Title: Limited Access Control Changes (LACCs) for Route 286 (Fairfax County Parkway) Widening of Southern Segment Fairfax County

CTB Decision Brief
Proposed Limited Access Control Changes (LACCs)
Route 286 (Fairfax County Parkway) Widening of Southern Segment
Project 0286-029-489, C501 (UPC# 122982)
Fairfax County

FAIRFAX COUNTY PARKWAY WIDENING SOUTHERN SEGMENT LIMITED ACCESS EXHIBIT

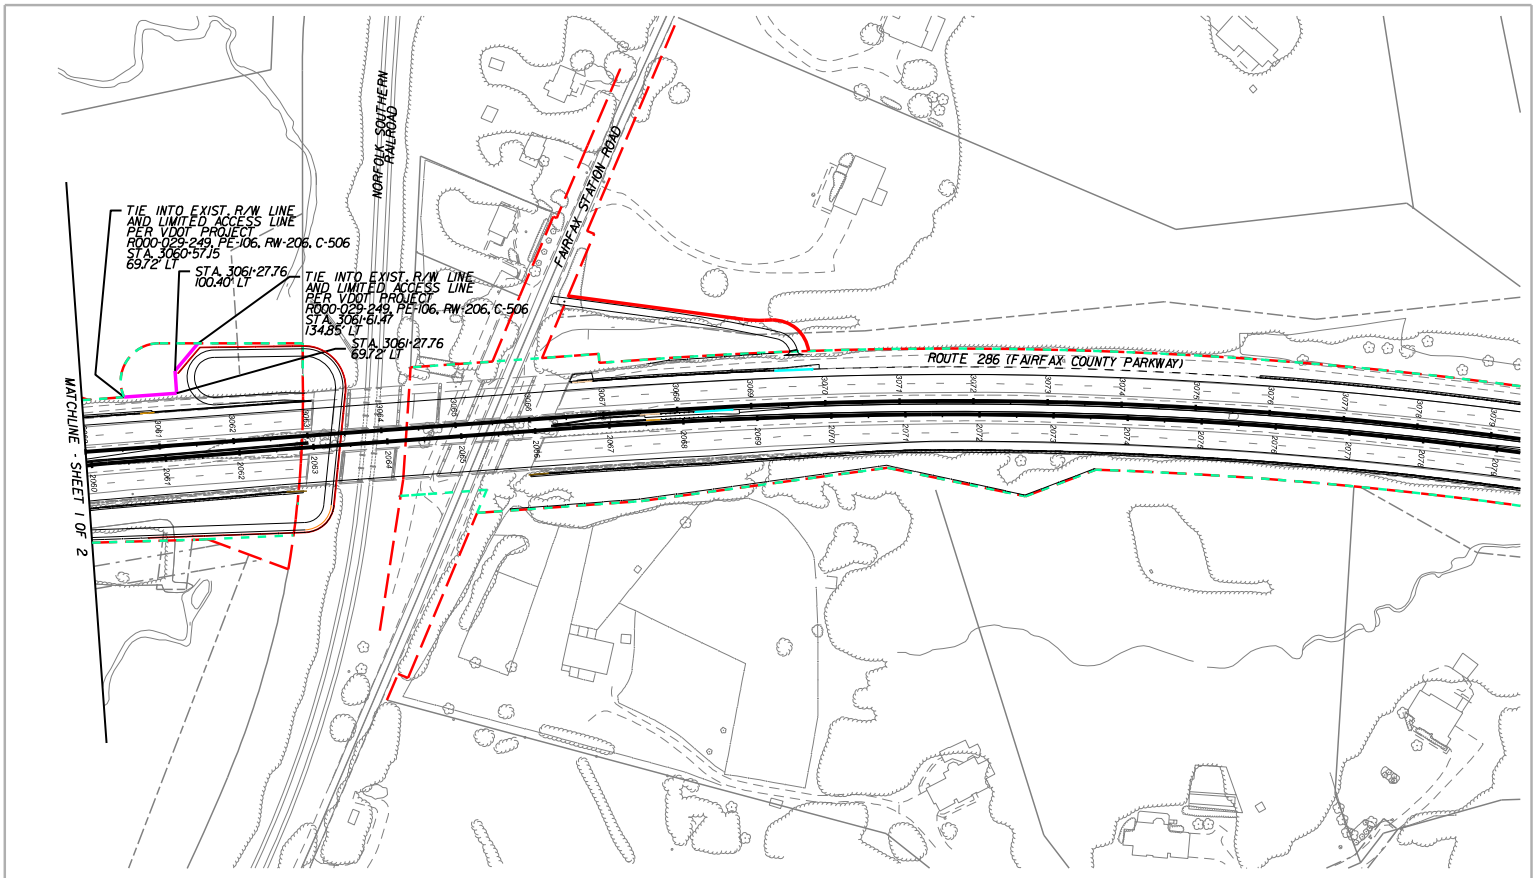
I understand the previously approved LACC needs to be modified. The current line location was established to accommodate the shared-use path crossing at the Norfolk Southern Railroad and Fairfax Station Road bridges. This proposed change, as is also shown on the attached exhibits, encompasses the following:

- To move the Limited Access Control Line back to coincide with the Limited Access Control Line and right-of-way which was established by the CTB resolution dated July 16, 1987. The Limited Access Control Line modified under the CTB resolution dated July 14, 2020, is no longer needed due to the intersection realignment at Burke Centre Parkway, which eliminates impacts to private property at this location.
- To shift the Limited Access Control Line (which had also been modified under the CTB resolution dated July 14, 2020), reducing the proposed right-of-way needed for the shared use path crossing at the Norfolk Southern Railroad and Fairfax Station Road Bridges. Optimization of the shared use path profile and retaining wall during final

design reduced the length of the trail by approximately 100 feet, minimizing the necessary limits of disturbance on the project.
